MEMO

1-5 Woodburn Street 6-8 Woodburn Street & 175-177 Cleveland Street, REDFERN

Environmental Assessment - Condition 22 – Infrastructure Requirements & Utilities

Diagram 1 – High-voltage connection on Cleveland Street, Redfern

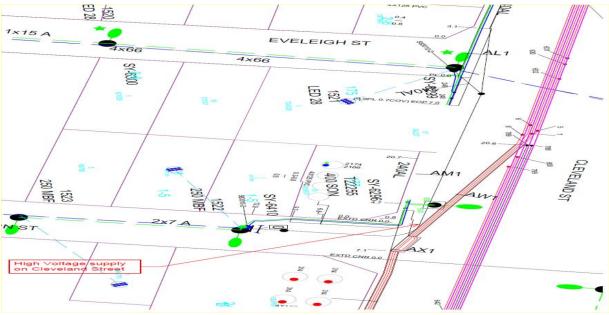
- We need to check how conduits enter from street to HV & LV pits. Is there capping beam? How Ausgrid conduits enter substation pit.
- Ausgrid 24/7 access from street to substation.
- All structure within 3m from substation louvred door must be 180/180/180 FRL.
- No fixed glass within 3m from substation louvred door.
- No ventilation ducts/exhaust within 6m from substation louvred door.
- Must have 3m separation from neighbour property to substation louvred door. You need to provide barrier wall to separate.
- Suite 4, Level 8, 20 Bridge Street | Sydney | NSW | 2000 | Australia

- No fire hydrant within 10 m from substation louvred door.
- Please show 3m,6m & 10m radius on ground floor plan.
- Substation earth rods will be installed at bottom basement natural ground. Please provide details of bottom basement. How many basements are below substation room.
- Where is main switch room in an adequate location for this development.
- Provide level 1 plan as well. Is there bed room above substation?

Ausgrid have advised that they will not develop and provide further investigation until the two sites are amalgamated into one.
